Jacuzzi Proto
MT8183 Chromebook Convertible
2019-12-16

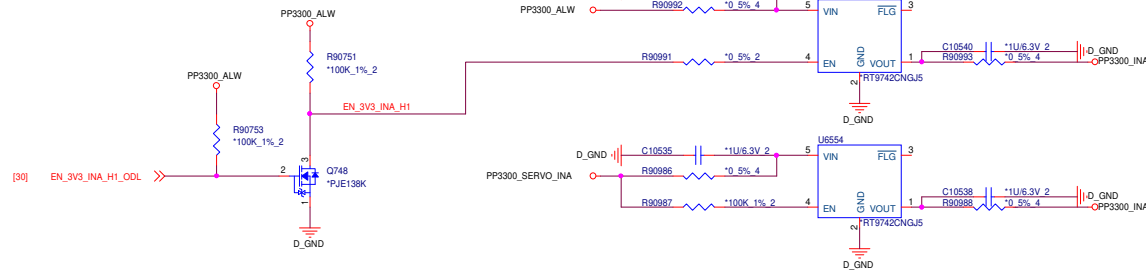
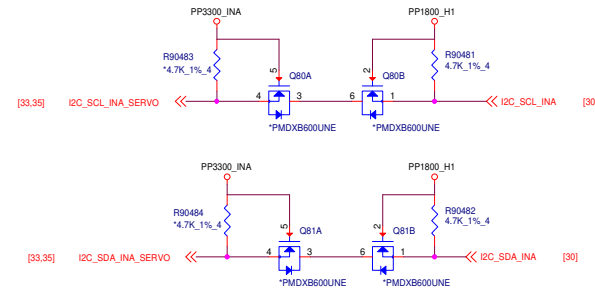
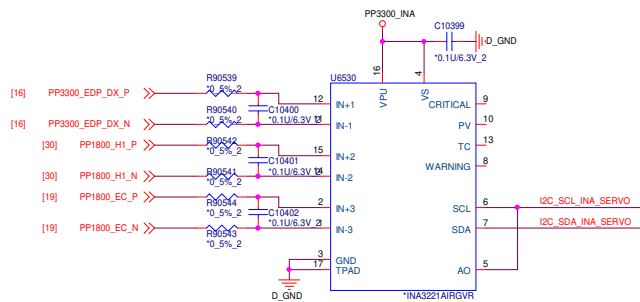
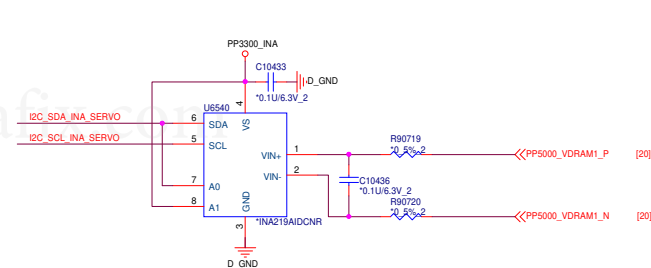
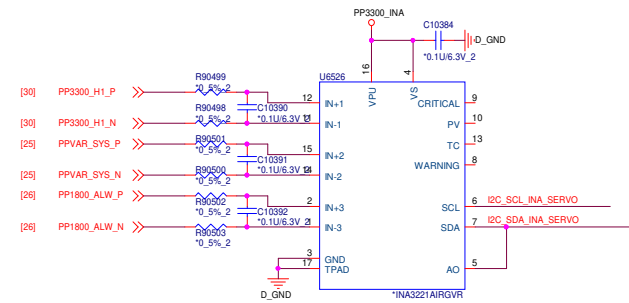
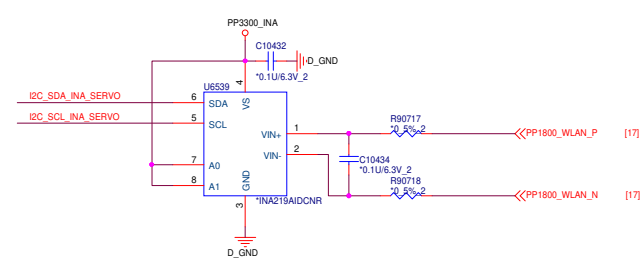
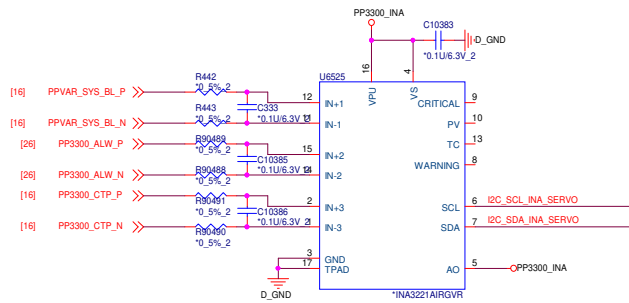
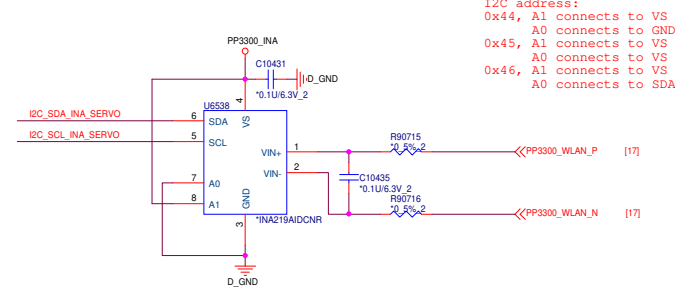
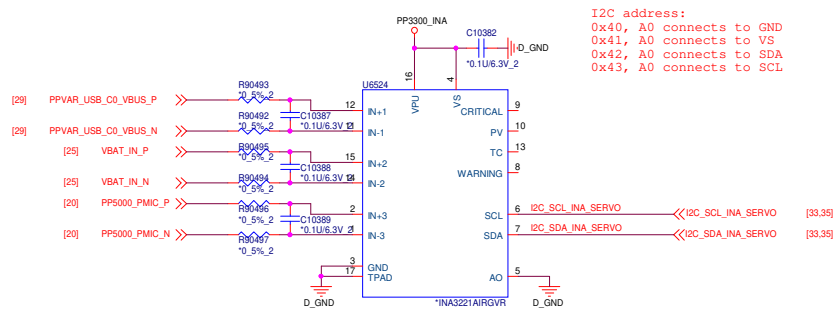
Data	Page	Item
5/27	16	change CON6801 & J19 to Bobba360 eDP panel connector J15(include DMIC connection too)
5/27	25	remove R90739, ISL9241_BYPSG, ISL9241_NGATE test point, add circuit as note pic
5/27	25,30	Add inveter circuit for BATT_DISABLE_ODL net (PU 100K to PP3300_ALW) that connects to Battery Conn.
5/27	25	Add a power symbol ISL9241_5V for ISL9241 VDD (pin18)
5/28	30	U124 B4 pin connects to KSI2, A5 pin connect to EC_KSO2_INV, A8 pin connects to EC_KSI2, B8 pin connects to KSO2
6/3	7	AE24 pin net name PANEL_3V3_ENABLE, AE25 net name LCD_POWER_EN connect to page 16, AJ25 pin net name USB_POWER_EN connects to page 12
6/3	16	change R91125 connects to PP3300_S3
6/3	16	remove U6549 circuit
6/3	16	change R90695 connect to PP3300_S3
6/3	12	change U6552 to 0.5A PN
6/3	16	VSYS_BL_P/VSYS_BL_N connect to R391. Maybe move R391 to VSYS/R259 location is more better
6/3	19,32	change GAUGE_INT_ODL to RGB_INT_ODL connects to page U6574 pin 5 . R90865 remove

6/3	34	add DPI/I2S level shift circuit & 3.3V power back as backup for PCB size
6/4	1	Update block diagram
6/4	17	consider to remove U6534, U6535 circuit.
6/10	16	Please change U260 from LDO(RT9018) back buck converter(RT5710)
6/10	25	Please connect replace PPVAR_PWR_IN with PPVAR_USB_C0_VBUS.
6/11	25	AONP36336 and AONR36336 seem to have better power efficiency than SISA14DN. Please double confirm if there are other concerns like cost and thermal to replace SISA14DN with AONP36336x2 or AONR36336 x 4.
6/11	29	Change U6533 pin A2 from VBUS to PPVAR_USB_C0_VBUS
6/14	28	- add 0 ohm between LED_1_L and GPIO12/PWM1 of IT8801.- add 0 ohm between LED_2_L and GPIO13/PWM2 of IT8801. - add one more power led and LED_3_L to GPIO14/PWM3 of IT8801. (b/135086465)
6/14	25	A bi-directional power switch is required between USB-C connector and charger input: please add AOZ1375DI
6/14	28	RGB_INT_ODL to U6559.38 (IT8801), and add TP to all unused pins of IT8801

6/14	30	Add 0 ohm between EC_KSO2_INV and H1
6/14	34	Add USB-C MUX (IT5205) in order to resolve USB3.0 detection issue
6/18	25	Reserve a 0 ohm to bypass U6562
6/18	26	Change U6569 to RT6214HRGJ8F, PG is needed for PP1800_ALW_PG
6/18	1	Update the block diagram
6/18	12	Add WFC using DM4 and DP4 of U6546
6/18	16	Replace LCD_POWER_EN circuit with a fuse, and add another 1uF on EDP_BL_VOUT
6/18	28	DNS R90875 since there's internal pull up, and change net name from KB_VSTBY to PP3300_KBC
6/18	28	Assign LID_ACCEL_INT_L to U6559.39 (GPIO11)
6/18	34	For I/O power of IT6505 (TX_OVDD), please add a power switch and use VSIM2_PMU as enable pin. PS. For proto build, please pick 3V3 as default route
6/18	34	(a) AC caps on SSTX lines should be 0.1uF; while AC caps on SSRX lines are 0.33uF (b) From loss perspective, please use 0201 size for caps and resistors on SSTX/SSRX lines (and void pads in layout)
6/18	34	[Netname fix] DDIO_TX*_P -> DP_LN*_P; DDIO_TX*_N -> DP_LN*_N; DDIO_AUX_P -> DP_AUX_P; DDIO_AUX_N -> DP_AUX_N; AUX+ -> USB_C0_SBU1_MUX; AUX- -> USB_C0_SBU2_MUX

6/18	29	FSUSB42UMX is not required, please follow h1 ref.
6/18	34	Connect IT5205 to EC_I2C1_1V8_* with level shifts, and mount R941/R942
6/18	25	Remove AOZ1375DI since it does not support dead battery mode. Please follow kukui using U6561(FPF2495UCX) and U6558 (NX20P5090UK), EN_USBC_CHARGE_L and EN_PP5000_USBC.
6/18	19	Update EC GPIO pin assign
6/20	30	DNS/NC R90640
6/20	30	Add netname onto U124.J5: EC_BOOT_DFU
6/20	33	Please reserve testpoints onto servo header NC pins
6/20	33	[Netname for nit] DEBUG_UART_POWER -> AP_UART_VREF ; DEBUG_EC_UART_POWER -> EC_UART_VREF ; H1_DEBUG_POWER -> H1_UART_VREF ; LID_OPEN_L -> LID_OPEN
6/20	33	Connect LID_OPEN to servo header pin44 via a 0ohm
6/20	28	Remove EC_WAKE and the interrupt OR circuit
6/20	19	KB_INT_ODL to EC's PA8 with a 0 ohm
6/20	30	Remove PWRBTN, PWRBTN_R and add TP on U6548.4
6/20	28	The note in p28 about R90857, should be R91143
6/20	30	Reserve 0 ohm bypassing U12A.3->1 and U12B.5->7

6/20	32	Add a mosfet onto LID_ACCEL_INT_L as level shift
6/20	12	Reserve a 0-ohm resistor array (can be replaced by EMI choke) for DP/DM near USB-A connector
6/20	12	[For nit] 2. USB_A_POWER -> PP5000_USB_A0_VBUS 3. USB_HUB2_DM -> USB2_A0_N 4. USB_HUB2_DP -> USB2_A0_P 5. TYPEC0_USB_DM -> USB_C0_USB2_N 6. TYPEC0_USB_DP -> USB_C0_USB2_P 7. USB_HUB1_DM -> USB2_HUB_P1_N 8. USB_HUB1_DP -> USB2_HUB_P1_P 9. USB_HUB3_DM -> USB2_HUB_P3_N 10. USB_HUB3_DP -> USB2_HUB_P3_P 11. HUB_USB4_DM -> USB2_HUB_P4_N 12. HUB_USB4_DP -> USB2_HUB_P4_P 13. USB_WFC_N -> USB2_WFC_N 14. USB_WFC_P -> USB2_WFC_P 15. VSYS_PMIC -> PP5000_PMIC 16. VSYS_PMIC_P -> PP5000_PMIC_P 17. VSYS_PMIC_N -> PP5000_PMIC_N 18. PMIC_FORCE_RESET_OD -> EN_PP5000_ALW_L
6/20	1	Update block diagram
6/20	19	Change netname from OTG_EN to EN_OTG
6/20	29,30	Remove R90585/Q719/R90586, re-connect AC_PRESENT to ACOK_OD and add a 100kOhm pull-up to PP3300_H1

6/20	19	EN_USBC_CHARGE_L to EC's PC7, EN_PP5000_USBC to PD2
6/20	25	Remove J927 and related components, change H1_CHASSIS_OPEN to H1_BATT_PRES_ODL with 499K pull up to PP3300_H1
6/20	26	Add a test point on PP3300_ALW_PG
6/20	25	Remove R58 and CD5, add 100k serie resistor from EC_BATT_PRES_ODL to R293
6/20	25	Battery I2C interface should be connected to EC_I2C2_3V3
6/20	25	Change ISL9241 I2C interface to EC_I2C2_3V3
6/20	25	PPVAR_CHG_VIN should be replaced by PPVAR_PWR_IN.

Data	Page	Item
6/20	25	1. Add netname to CON15.5 "BATT_TEMP" 2. Change R293 to 100kOhm 3. Connect BATT_TEMP to H1_BATT_PRES_ODL via a 0ohm 4. Connect BATT_TEMP to BB_BATGONE via a DNS'd 100kohm
6/20	25	Change BATT_TEMP circuit
6/21	32	Remove note "IMU sensor has to be placed as close (<4cm) to WF CAM"
6/21	19,32	ACCEL_INT_ODL -> BASE_ACCEL_INT_ODL
6/21	25	Change charger IC to ISL9238
6/21	34	Change C10649,C10650,C10651,C10656 to 0.22uF
6/21	19	Reserve an external pull resistor on EC PA14. (1k ohm to PP1800_EC)
6/21	19	- Reserve an external pull resistor on EC PC13. (100k ohm to PP1800_EC) - R91178 can be DNS
6/21	16	Change the backlight control
6/24	14	Remove R90723
6/24	19	Add testpoints on EC's unused pins
6/24	28	Reserve stuffing options for IT8801 on EC_I2C1
6/24	10	DNS R90729 since LCM_ID will not be used for Jacuzzi
6/24	12	Add a note near CON481 "Change to USB2 connector from EVT"
6/24	12	Add capacitor(s) on PP5000_USB_A0_VBUS near USB-A connector, the total capacitance should be >120uF by spec.

6/24	16,19,25,26	[Netname] 1. EN_PP5000_ALW_L -> PMIC_FORCE_RESET 2. VSYS -> PPVAR_SYS
6/24	12,19	1. Change USB_A_POWER_EN to EN_USB_A_5V 2. Connect EN_USB_A_5V to EC's PC14 3. Reserve connection to USB_A_POWER_EN via a DNS's 0Ohm
6/24	-	[Netname] 1. ISL9241_5V to ISL9241_LDO_5V 2. RGB_INT_ODL to ALS_RGB_INT_ODL 3. LID_ACCEL_INT_L to LID_ACCEL_INT_ODL
6/24	30	Change R91116 / R91115 from Q762.3/Q763.3 to Q762.2/Q763.2
6/24	30	Change Q762.1/Q763.1 from PP3300_H1 to ISL9241_LDO_5V
6/24	28	1. LID_ACCEL_INT_ODL to EC's PA14, no external pull high 2. ALS_RGB_INT_ODL to EC's PC4, no external pull high 3. Reserve TP on IT8801 side
6/24	34	Having a 0 ohm from VSIM2_PMU to TX_OVDD, DNS U6576
6/24	22	PPVAR_CHG_VIN is signal net, should change to PPVAR_PWR_IN
6/24	25	Check battery spec to determine stuffing option of Q785/Q55/R420/C299.
6/24	25	Adding 20m ohm between PQ2.1 and VSYS, connect to VSYS_P / VSYS_N instead of R612

6/24	25	Reserve ASGATE control with PFET from PPVAR_USB_C0_VBUS to PPVAR_PWR_IN
6/24	10,19	Please complete HWID tables in schematic
6/24	16	1. Rename TP_INT_1V8 to TRACKPAD_INT_1V8_ODL, with an external 100kOhm pull-up 2. Remove Q733 and R91114 3. Change Q732 & Q734 design similar as in column K 4. Please use 100kOhm for external pull-up on interrupt
6/25	19,32	1. Use SPI as default interface from EC to BMI160, and reserve I2C 2. EC pins need to be moved around, please see link in column K
6/25	8	1. Connect EC_VOLUP_BTN_ODL to AP's EINT5 via a 0ohm 2. Connect EC_VOLDN_BTN_ODL to AP's EINT6 via a 0ohm
6/25	25,30	[Netname] *9241 to *9238C
6/25	30	[BOM] 1. DNS U12, R91088, R90386, R90387, R91188, R91189, C10620 2. STUFF R91115, R91116
6/26	19	[BOM] Stuff U6547/ Q750 / R90880 / C10469
6/27	19	[BOM change] For Jacuzzi, we decided to reset EC_BOARD_ID. Please change R90473 to 2.2kOhm and modify the table accordingly

6/27	30	Kukui post_p2 #28 didn't get introduced: 1. Update reset map to v2.3 2. Change R90973 & R90410 to 4.7kOhm (and modify the strap table)
6/27	8	Note near R90591: "Remove JTAG connections after proto"
6/27	10	Note near LCM_ID: "NOT USED IN JACUZZI"
6/27	25	[BOM change] 1. Mount Q789 2. DNS U6558 and U6577
7/19	25	ISL9238C ds suggests C437 to be at 50V rating, to have effective capacitance higher than 0.4uF at 20V
7/19	30	DNS R91087, R91089, R91092, and R91093
7/19	1,2	Please update block diagram and I2C table accordingly
7/19	16	DNS R218 as RT5710AHGQW cannot stand PPVAR_SYS as input power
7/19		LCM_RST_L_1V8 -> MIPIBRDG_PWRDN_L_1V8 ; EC_VOLUP_BTN_ODL -> VOLUP_BTN_ODL ; EC_VOLDN_BTN_ODL -> VOLDN_BTN_ODL ; PS8640_1V2 -> PP1200_MIPIBRDG PS8640_VIN -> PP3300_MIPIBRDG_DX ; PP3300_LCM -> PP3300_EDP_DX ; PP3300_PANEL -> PP3300_EDP_DX_R ; PP3300_LCM_P -> PP3300_EDP_DX_P PP3300_LCM_N -> PP3300_EDP_DX_N ; PANEL_3V3_ENABLE -> EN_PP3300_EDP_DX

7/19	12	Connect U6552 FLG pin to U6546 OVCUR2# pin, with a 100kOhm external pull-up and netname USB_A0_OC_ODL
7/19	29	Fix typo: Brealdown to Breakdown
7/19	4	Add power tree into schematics
7/25	19	Remove the following connections to EC: - CHARGER_PMON (R91177) - EN_OTG (R91193/R91180) - CHARGER_IADP (R91176)
7/25	29	Need to have discharge path on PPVAR_USB_C0_VBUS. Adding a NFET which is controlled by U6517.PB6 with 1.2K (0603) discharging resistor. The net name is USB_C0_DISCHARGE.
7/25	25	[Net name] 1. VBAT to PPVAR_BATT 2. VSYS_BL_* to PPVAR_SYS_BL_* 3. VSYS_P to PPVAR_SYS_P, VSYS_N to PPVAR_SYS_N 4. VSYS_SMPS to PP5000_SMPS 5. VSYS_V* to PP5000_V*
7/25	19	Remove note "reserved to enable PP1800_EMMC for developing only"
7/25	2	Please update the i2c table for jacuzzi and add ec i2c block diagram
7/25	25	Swap polarity of VBAT_IN_N/VBAT_IN_P on R90819
7/25	19	DNS R91208, since driver is not using LID_ACCEL_INT_ODL

7/25	26	Change R90668 to 0603 package
7/30	7,16	VDDIO_MIPIBRDG_EN -> EN_PP3300_MIPIBRDG_DX
7/30	34	Change USB-C MUX from IT5205 to IT5204 for cost benefit
7/30	19	Change R90880 to 100kOhm to save power when write protection is off
8/8	28	Reconnect EC_KSO2_INV to IT8801 pin KSO20 via a 0ohm
8/8	13	Add note for DA7219: THE TWO SENSE SIGNALS NEED TO BE CLOSE TO THE JACK CONNECTOR ROUTE HP_RING2 AND HP_RING2_SENSE TOGETHER (TREAT AS DIFF PAIR EXCEPT NO NEED FOR IMPEDANCE CONTROL) THE SAME APPLIES TO HP_SLEEVE AND HP_SLEEVE_SENSE SIGNALS ROUTE HP_RING2, HP_RING2_SENSE, HP_SLEEVE, HP_SLEEVE_SENSE BETWEEN HP_LEFT AND HP_RIGHT WHERE POSSIBLE

Data	Page	Item
8/13	4	Update power tree
8/13	28	[OEM] Add keyboard backlight circuit
8/13	28	[OEM] Reserve CON9105 Keyboard connector for 15"
8/13	31	[OEM] Change to sub board connector to 20pin
8/13	12,31	[OEM] Move USB connector to sub board
8/13	16	[OEM] Remove 2nd DMIC
8/13	7,16	[OEM] Change PS8640QFN56GTR2-A0 to ANX7625BN-AC-R ; Rename PP1200_MIPIBRDG_EN to PP1000_MIPIBRDG_EN ; R219 change to 147Kohm ; Add U6579 for ANX7625 1.8V
8/15	33	Change R91181 from 0 ohm to 1k ohm.
8/15	29	[OEM] Change ESD protect for cost benefit : Change U2,U3 from RCLAMP0524PATCT to AZ1045-04F.R7G ; Change D1 from RCLAMP0502BATCT to AZ4024-01F.R7GR Change ESD7105,ESD7106 from ESD73031N-2/TR to PESD5V0X2UM ; Change ESD7102 from AZ4520-01F.R7G to PE3620M1Q
8/15	32	[OEM] Reserve GMR circuit
8/20	19	Connect EC_PROCHOT_ODL to EC pin PC13, not PC14
8/20	2	Update block diagram and I2C table accordingly
8/20	29	Add a 1MOhm pull-down on USB_C0_DISCHARGE, to avoid being floating

8/20	19,25	Separate battery's SCL/SDA from EC_I2C2 bus:(a) BATT_SDA to EC pin PC4 (b) BATT_SCL to EC pin PA5 (c) 4.7kOhm pull-up resistors are required
8/20	25	Move R91200 to make sure PPVAR_SYS power consumption is readable via INA, in battery-only condition
8/20	19	Change R90880 back to 2.2k ohm. (refer to the comment of #14)
8/20	25,29	About PPVAR_USB_C0_VBUS, please reserve the following circuitry for experiment.
8/20	31	Add a 1kOhm series res from J17.16 to LID_OPEN
8/22	16	Add 0 ohm NC connects Q708 pin 1 to Q709 pin1. Add 0 ohm NC connects to Q707 pin1 to Q710 pin1
8/22	16, 24	Reserve U2001 XO_CEL pin 0 ohm NC connects to ANX7625 XTAL_OUT(C1 pin)
8/22	16	Add a 0ohm on ANX7625_XTAL_IN in case XTAL drive level needs to be tuned
8/22	16	ANX7625_INT_L -> MIPIBRDG_INT_ODL
8/22	8	Connect MIPIBRDG_INT_ODL to AP pin AC3
8/22	16	Pull-up R91238 to PP1800_AP instead of PP1800_MIPIBRDG_D
8/22	16	[Netname] (a) J15.13: PP3300_CAM (b) PP1800_MIPIBRDG_EN -> EN_PP1800_MIPIBRDG

8/22	7,16	Connect EN_PP1800_MIPIBRDG_DX to AP pin AE25 (GPIO36)
8/22	16	Reserve 0ohms bypassing Q708/Q709 and Q707/Q710
8/22	16	Reserve a testpoint on ANX7625 CABLE_DET for debug usage
8/22	16,21	Reserve power path from VCAMIO_PMU to PP1800_MIPIBRDG
8/22	16	Move C10525 to PP3300_EDP_DX, close to eDP connector
8/22	16	Fix note of R252: "TODO: VALIDATION OF SHARING POWER BETWEEN BRIDGE AND EDP PANEL"
8/22	16,21	Reserve power path from VMCH_PMU to PP3300_MIPIBRDG_DX
8/27	32	Add note to GMR sensor: "DNS IF GMR IS ON SUB-BOARD"
8/27	4,26	Change U6570 to RT6256C and U6571 to RT6256B to improve power consumptoin. Update power tree
8/27	28	[OEM] Remove keyboard backlight circuit
8/27	34	Change ac coupling capacitors to follow it6505fn_v35_20190722.pdf (need to verifiy on proto board)
8/29	19,26,30,32 35	[For G3 power consumption] (a) Add LDO for powering PP1800_EC and PP1800_H1, input from PP3300_ALW. Netname PP1800_LDO (c) Change R90987 to 100kOhm, and reconnect U6554 EN pin to PP3300_SERVO_INA with R90987 (d) Change R91148 to 1MOhm (e) Reconnect PP1800_ALW_PG to PP1800_H1_PG (f) Modify H1_RST_ODL circuit as shown in note (g) Change R91196 to 100kOhm, still DNS'd (h) Add control circuit from EC PA14 via a 0ohm to U6569 EN, a mosfet inverter is needed as EC cannot take PPVAR_SYS voltage. Netname EN_PP1800_S5_L

8/29	25	Add a PMOS back-to-back with Q789 to avoid negative power source going into ISL9238C ADP pin, whose AMR minimux is -0.3V
8/29	26	Add a 0 ohm between EC PA14 and EN_PP1800_S5_L. Populate this resistor by default.
8/29	26	Reserve 1M ohm (DNS by default) between LDO3_VOUT and the EN pin of RT6256CGQUF.
8/29	19	Add a 499k ohm between LID_OPEN and PP1800_EC. (To allow system bootup without GMR)
8/29	8	Please reserve a serial 0ohm on MIPIBRDG_INT_ODL.
8/29	34	[ITE suggestion] (a) DP_AUX_N reserve P/D 300K ohm (b) Change C10652,C10653 to 0.68uF (c) Add 100K P/D between IT5204 CTX/CRX and AC caps (d) Add serial 0ohm on USB_C0_SBU1_MUX/USB_C0_SBU2_MUX (e) Add serial 22ohm on EC_I2C_USB_C0_MUX_SCL/SDA
8/30	19,29,30	Some PP1800_ALW should be changed to PP1800_LDO or PP1800_EC - Q739A.5 (PP1800_EC) - R619 (PP1800_EC) - R338 (PP1800_EC)
8/30	8	Nit: remove note for MDSI_TE "NEAR CON9102"
8/30	29	For better ESD protectoin and filtering, move ESD7102, C518, and C10637 to be closet to USB-C connector.

9/2	19	Stuff R90868
9/10	19	Change BOARD REV ID from 0 to 1
11/4	25	Having 0 ohm to bypass Q801 for cost saving, since it's for reverse plugging protection
11/4	19	It's better to add and populate 0 ohm by default between. - EC_I2C2_3V3_SCL and BATT_SCL_3V3, - EC_I2C2_3V3_SDA and BATT_SDA_3V3
11/4	34	Please refer to it6505fn_v36_20190903.pdf (Add R91298)
11/4	21	Add a 0 ohm (populate by default) between DVDD18_TO (U2001.L9) and VIO18_MT6358 and de-populate R90656.
11/4	33	Change R91181 (LID_OPEN) back to 0 ohm
11/4	12	Please add resistor of 0 ohm on USB2_DM and USB2_DP. (For USB SI measurement)
11/4	12	Change R90741 from 680 ohm to 619 ohm for USB2.0 S/I
11/4	2	Update EC I2C MAP for bigbang
11/4	29	Netname nit: BC12_POGO_ADDR -> BC12_C0_ADDR, BC12_POGO_EN_L -> BC12_C0_EN_L
11/7	19,25	Change ISL9238CHRT2-T's I2C to EC_I2C2_3V3_SDA from BATT_SDA_3V3 ; to EC_I2C2_3V3_SCL from BATT_SCL_3V3
